Meeting: 11/19/2025
Applicant: Wendy Boles
Owner: Wendy Boles
District: Lonsdale Infill Housing Overlay District

Location: 0 Bragg St. **Parcel ID:** 81 P E 012
Zoning: RN-2 (Single-Family Residential Neighborhood)
Description: Preliminary plat

DESIGN REVIEW BOARD	11-F-25-IH	Petitioner: Wendy Boles
	APPLICATION FOR CERTIFICATE OF APPROPRIATENESS	
	 0 Bragg St. Lonsdale Infill Housing Overlay District	  Feet
	Original Print Date: 11/7/2025 Knoxville - Knox County Planning - Design Review Board

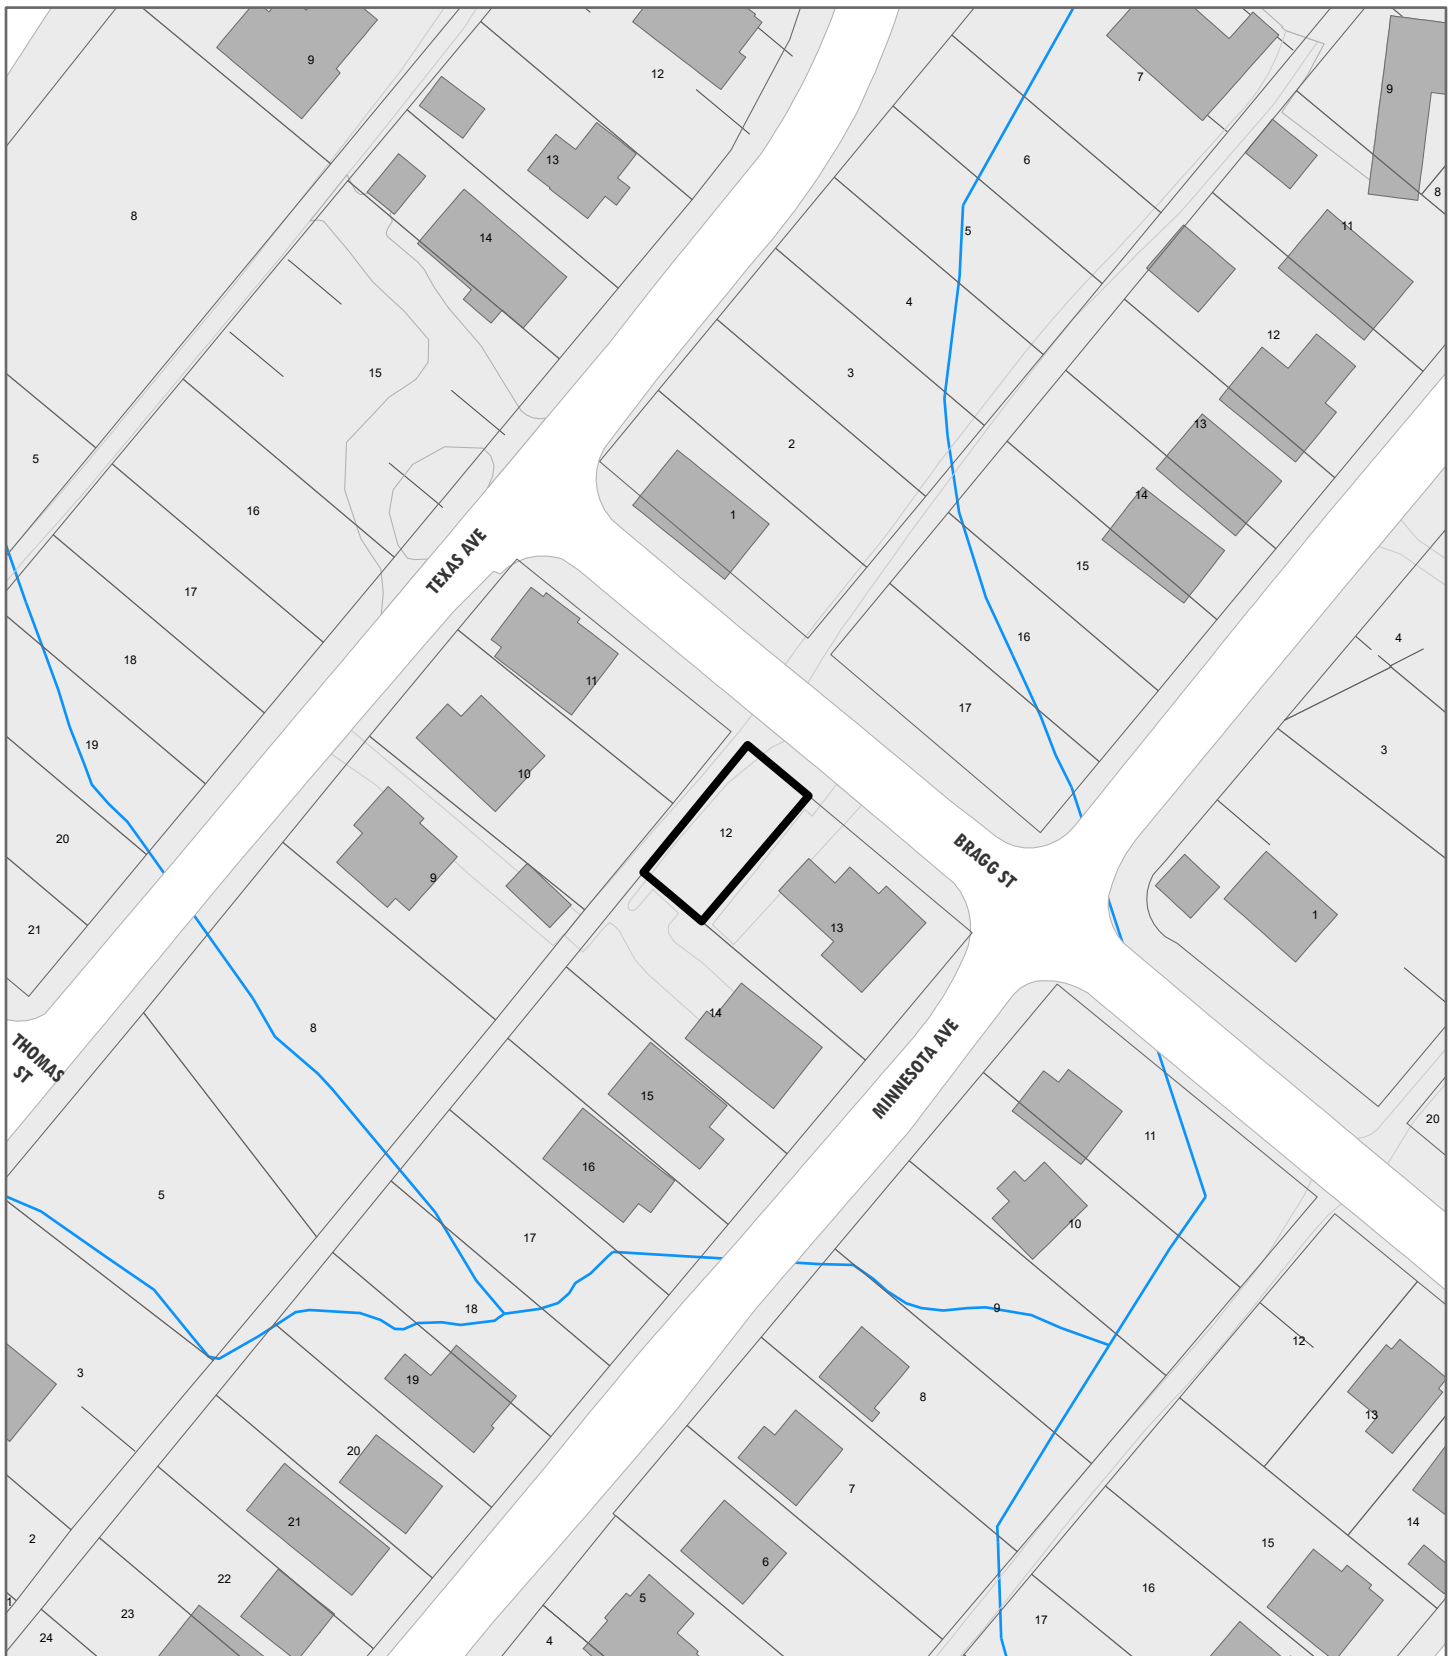
1. Plats that do not meet the Infill Housing design guidelines, which encourage creating 50' wide lots, require approval by the Design Review Board. The proposed lot would not meet the 50' minimum lot width or the 5,000 square foot minimum lot area required under the RN-2 (Single-Family Residential Neighborhood) zoning. It can only be platted if approved by the Board or with multiple variances from the Board of Zoning Appeals.

3. This proposed lot contains rear sections of two platted lots that are part of the adjacent parcel with 1501 Minnesota Avenue. A one-and-a-half story building was constructed sometime between 1917-1935, and it was demolished sometime between 1985-1995; it was likely used commercially for its entire existence. If platted, this would be the only lot on the block with frontage on Bragg Street. However, there are houses a couple

4. Approving the plat would align with the historic use of the lot and recreate a historic development pattern in Lonsdale that has continued to be replicated. It is not possible at the moment to recreate the original lot size because 1501 Minnesota Avenue is centered between two lots. The lot would not disrupt the setback pattern and streetscape of Minnesota Avenue, and the Board would review plans for new construction, ensuring that it would not disrupt the setback pattern along Bragg Street. However, it would lead to inconsistent spacing between the houses that does not align with the guidelines. In the opinion of staff, platting the lot can be appropriate because it reflects the historic use of the lot, recreates a historic development pattern in Lonsdale, and any new construction would be reviewed by the Board to ensure that it is compatible with the context.

Staff recommends approval of Certificate 11-F-25-IH, subject to the following conditions: 1) pending final approval until a formal plat prepared by a surveyor is submitted along with plans for new construction on the lot; 2) the current file number cannot be used to indicate Infill Housing approval on the final plat; and 3) the final plat to meet the Subdivision Regulations.

5. The dimensions on the tax parcel were provided in lieu of a formal survey to get approval of the general boundaries for the lot prior to obtaining a formal plat. However, a formal plat must come back to the Board for approval along with plans for new construction. The current file number cannot be used to show Infill Housing approval on the final plat.
